A Slippery Slope*

Exhibit MB-39 Part 1

Site Plan Reference Page

In the **Second Site Plan**, panels have been rearranged to be in two groups.

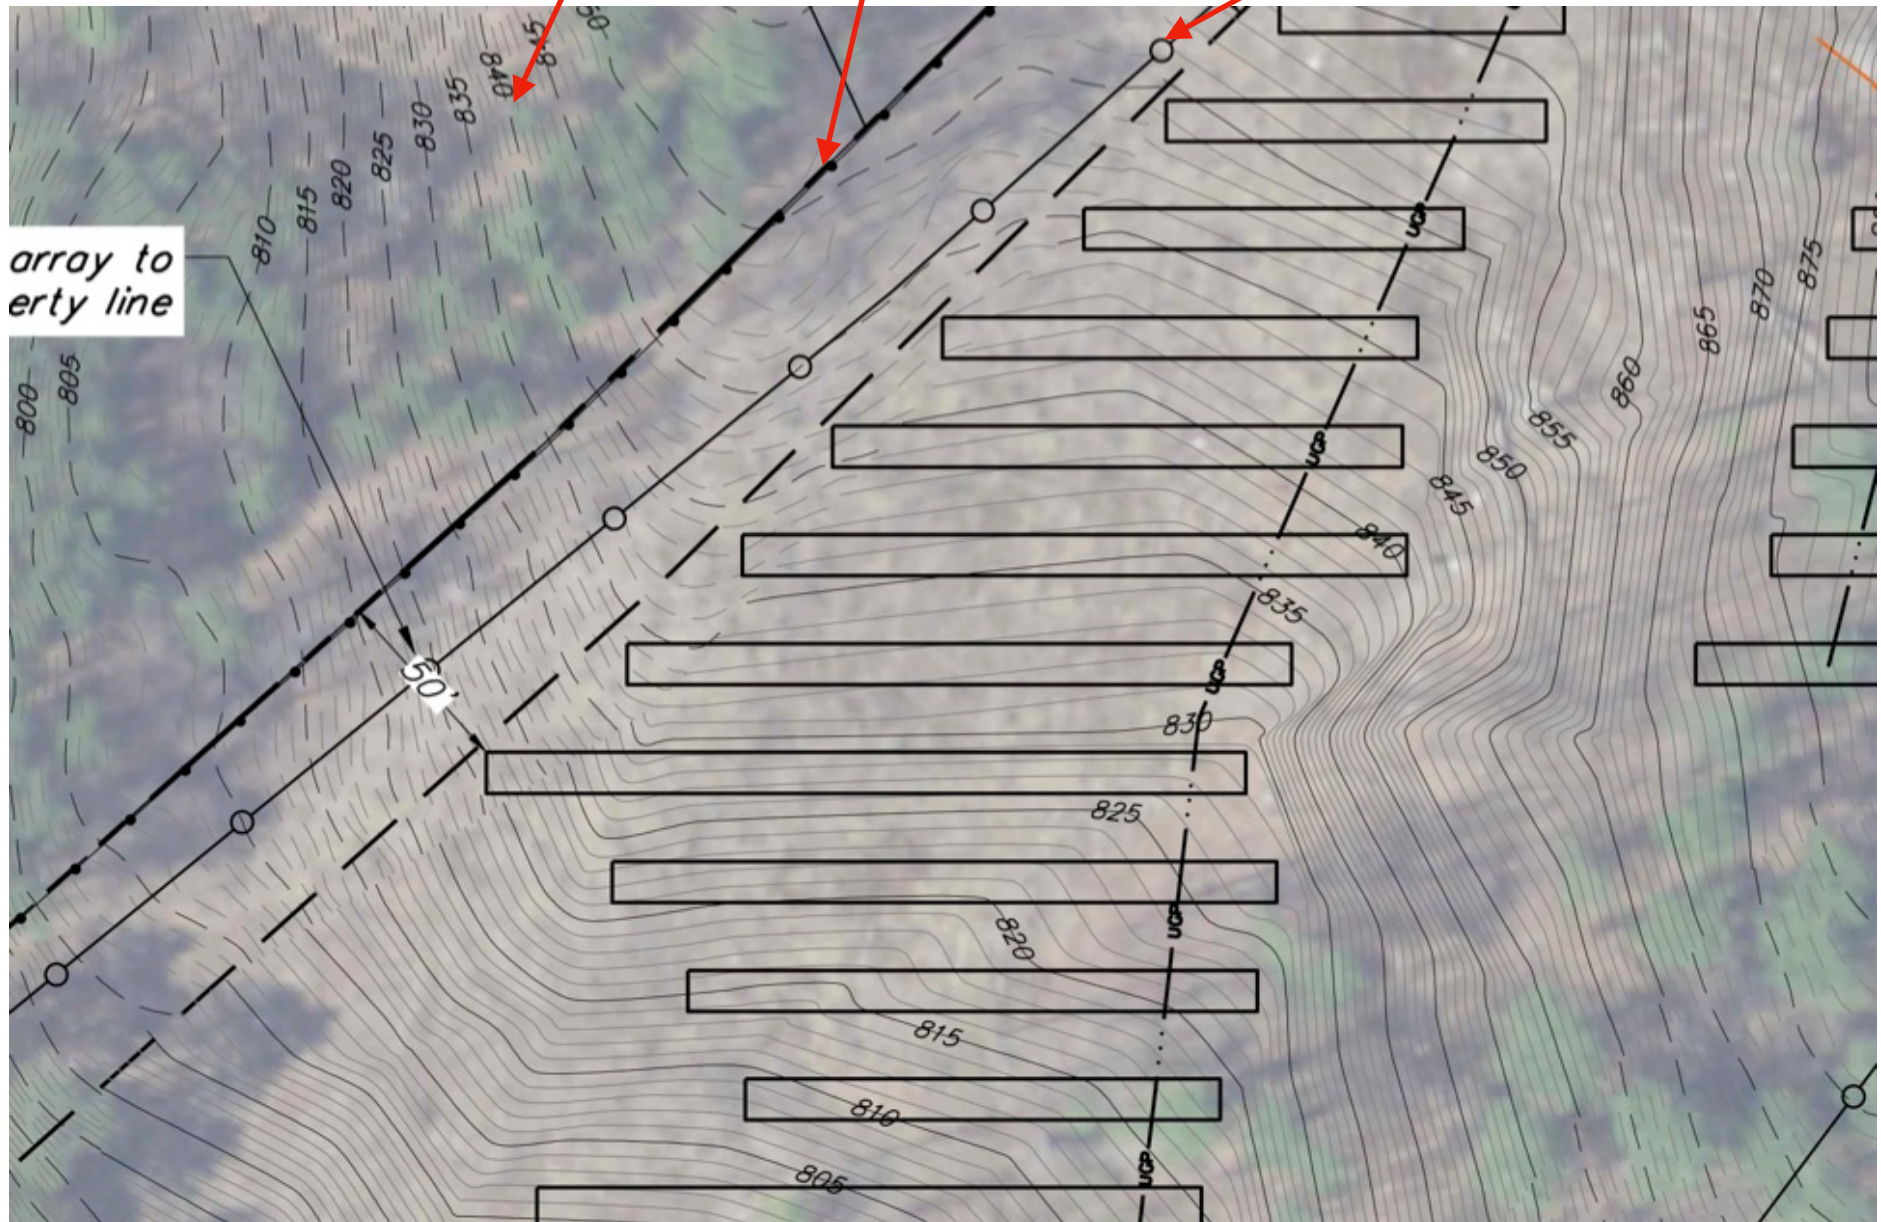
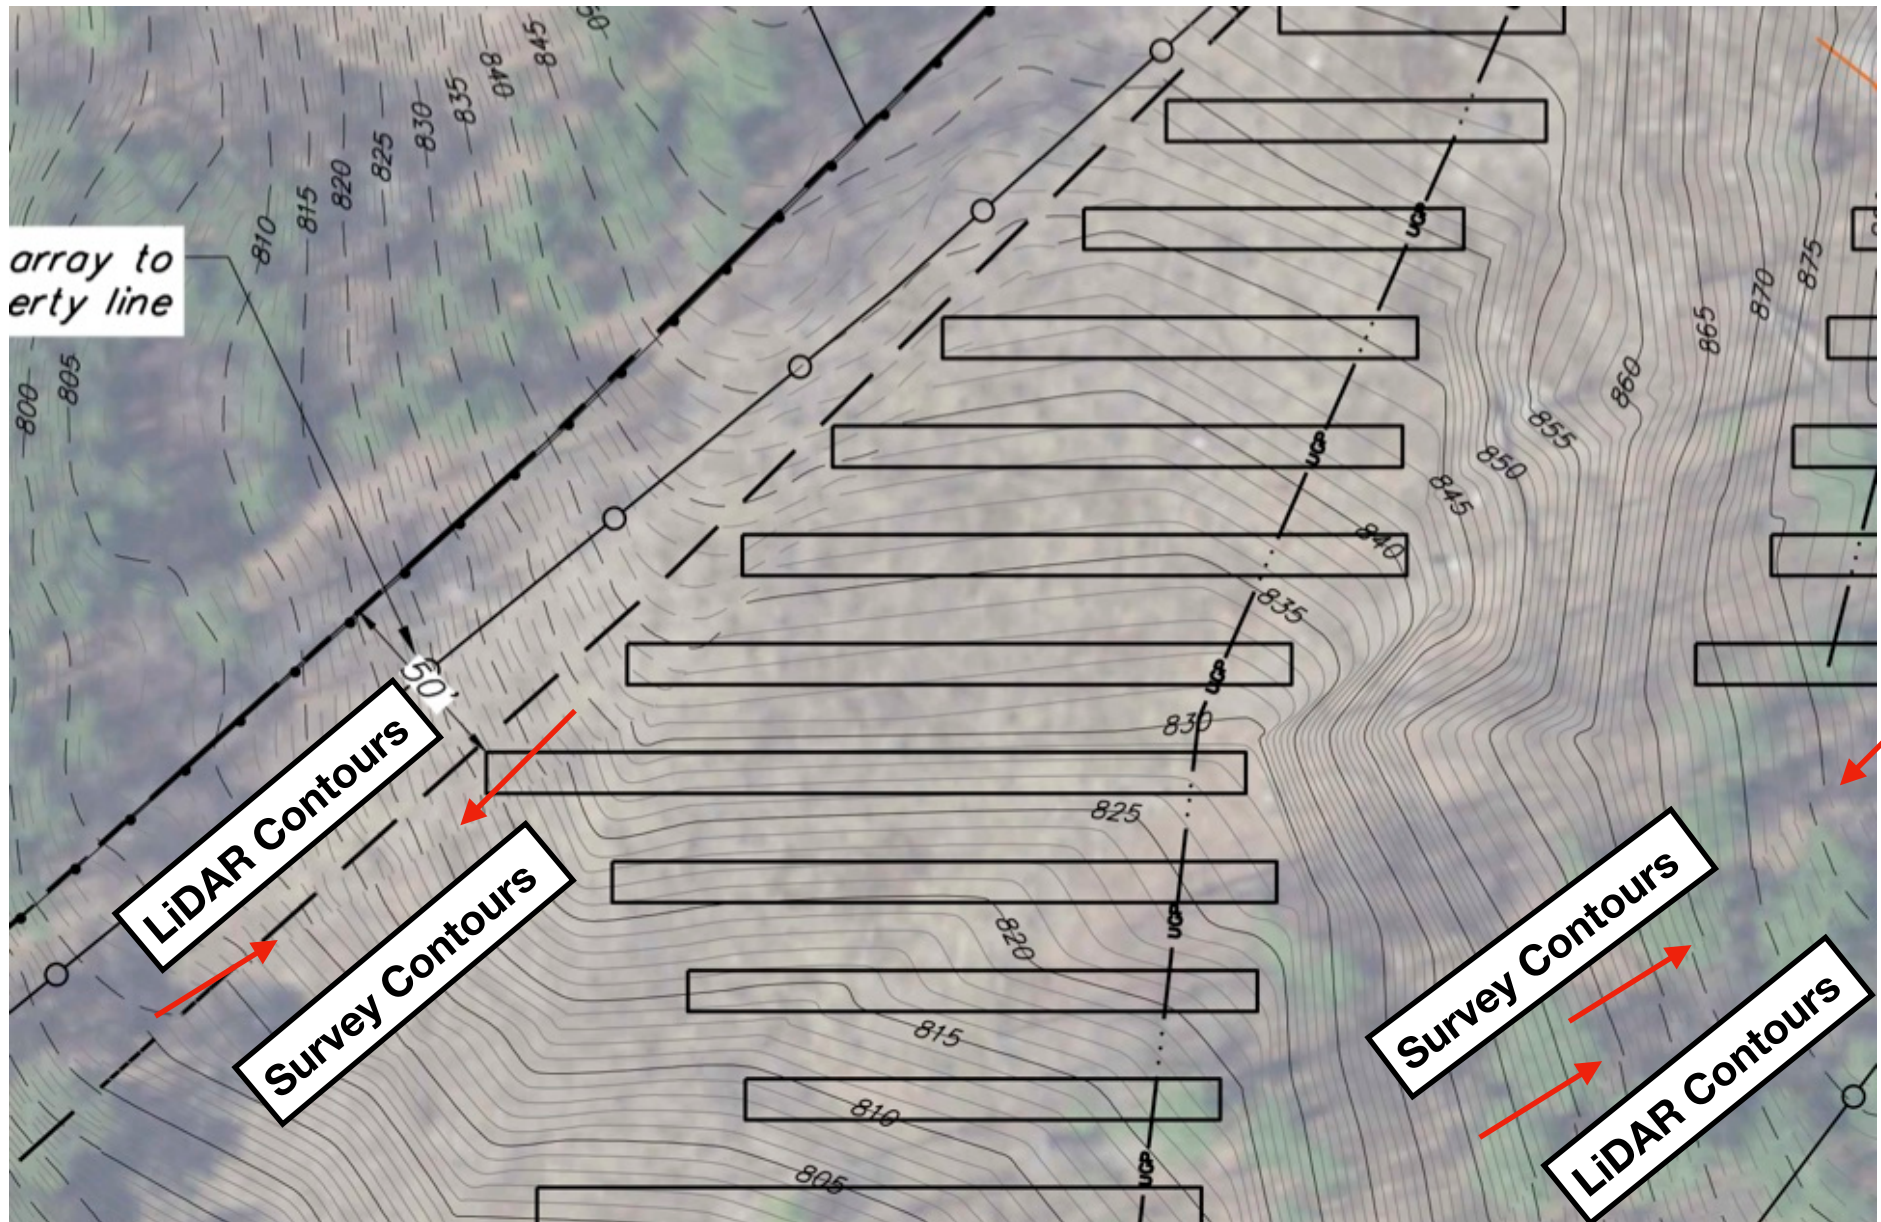
The contour lines under and around the array are derived from a ground based survey.

Discontinuities (Red Arrows) in the **Second Site Plan** are visible where the ground based survey is patched onto the LiDAR base layer

Discontinuities (Red Arrows) in the **Second Site Plan** are visible where the ground based survey is patched onto the LiDAR base layer

Northeast corner of the Site.
2nd Site Plan
5 ft major, 1 ft minor contours

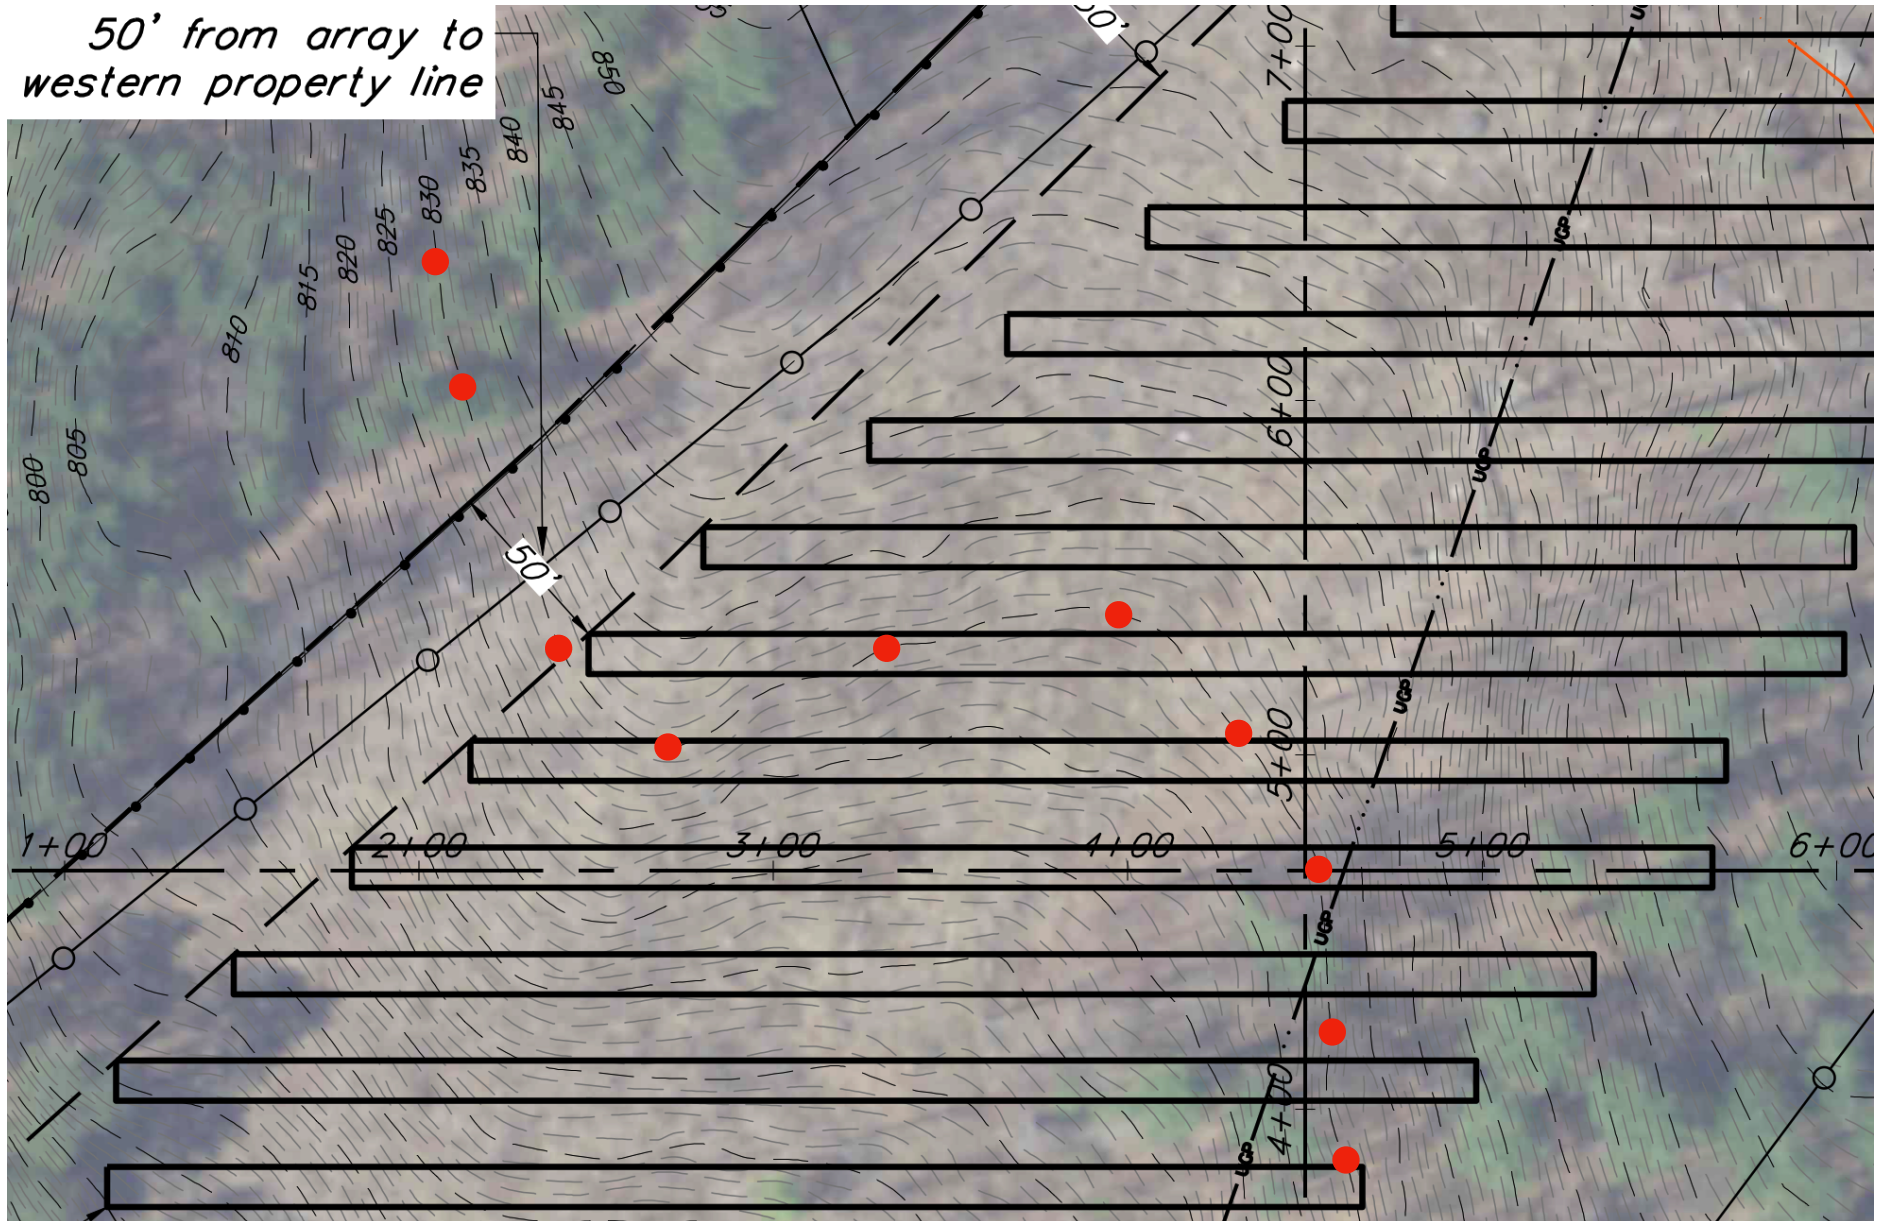
The local high point on the ridge is a 'double hump' at 905 and 906 ft elevation.

Note the discontinuities where the ground based survey was patched onto the LiDAR base layer.

All Site Plans after the 2nd Plan have 10 ft major contours and the 'double hump' is not seen because there is no 905 ft contour

In the **Second Site Plan**, the 830 ft Elevation is marked with Red Dots.

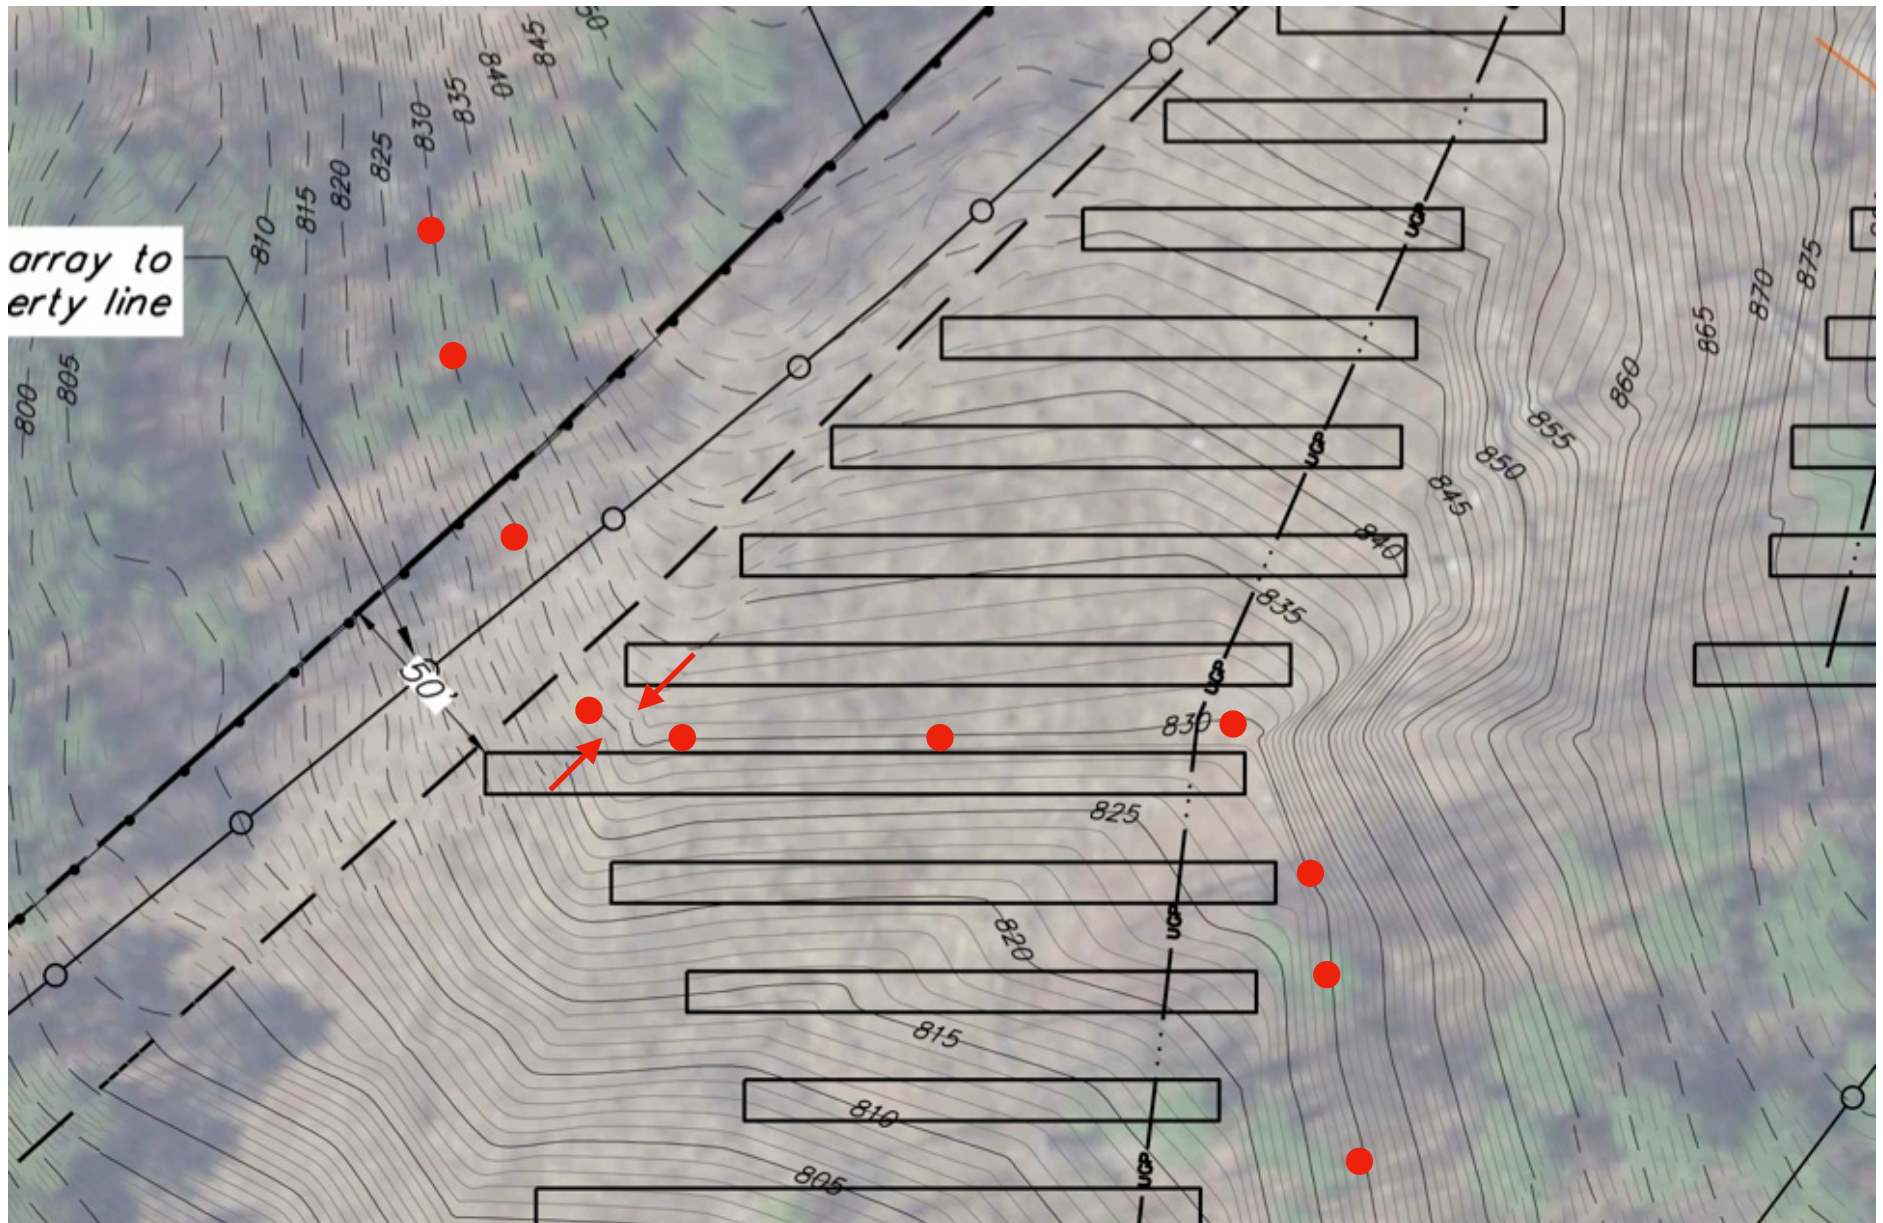
The surveyor did not locate elevations at enough points to accurately draw the contours.

The discontinuity runs through the 830 ft contour line at the Red Arrows.

Fourth Site Plan

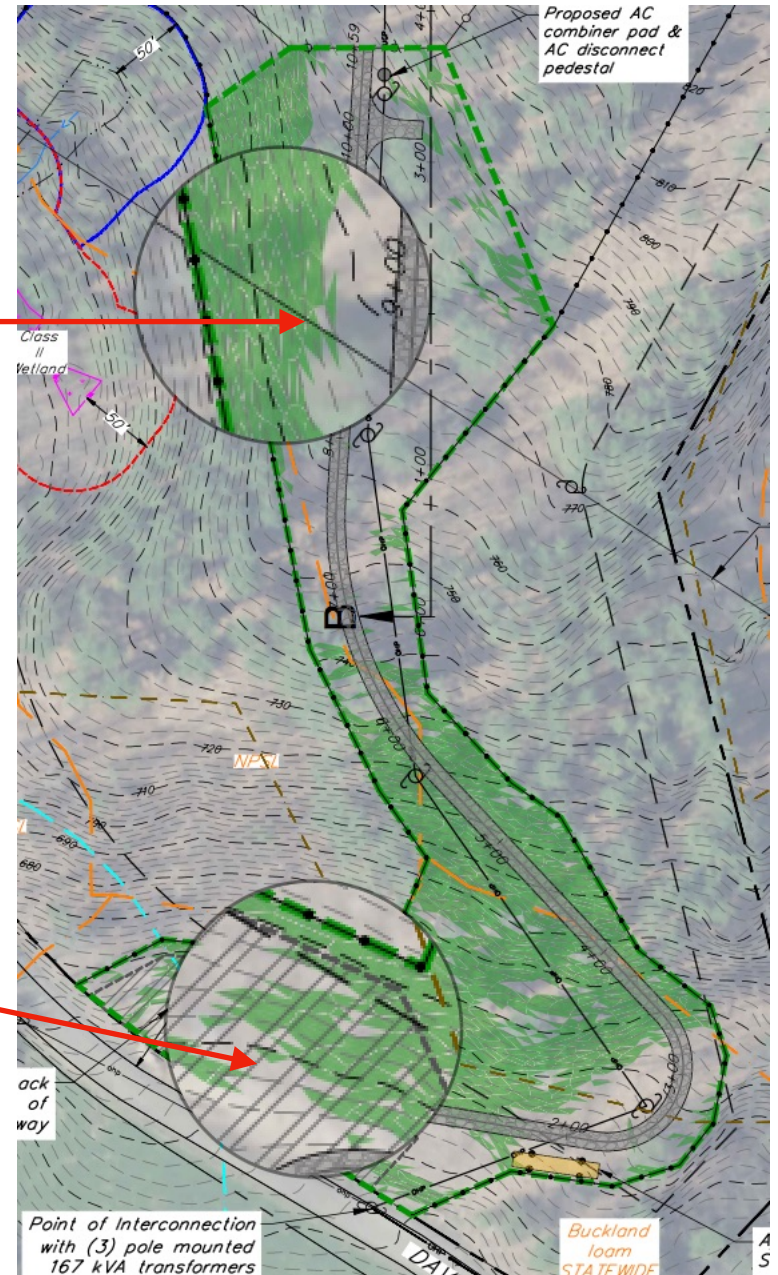
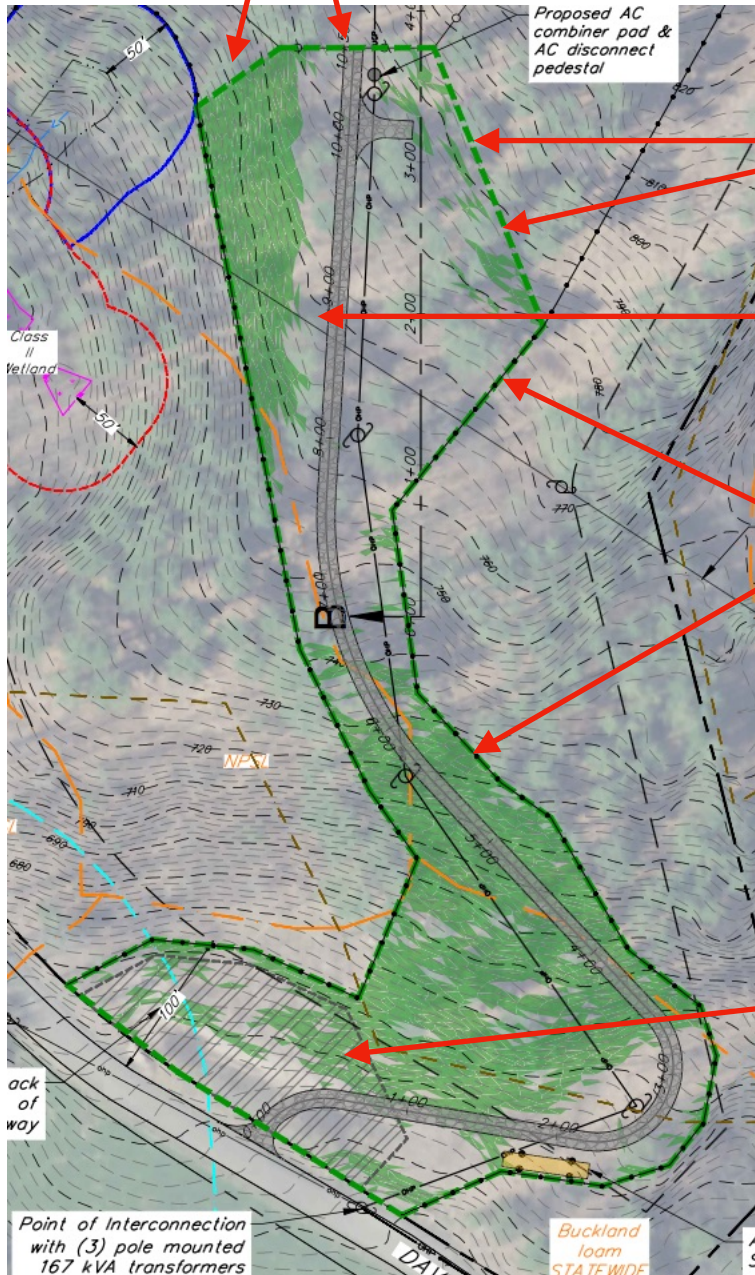
In the **Fourth Site Plan**, a greater than 25% LiDAR Slope Layer (Green) was added around the Access Road.

Note the “frayed” edges of the slope layer. The Frayed Edges are typical of what a slopes layer on a natural landscape looks like.

Artificial Boundary
of LiDAR Slope
Layer
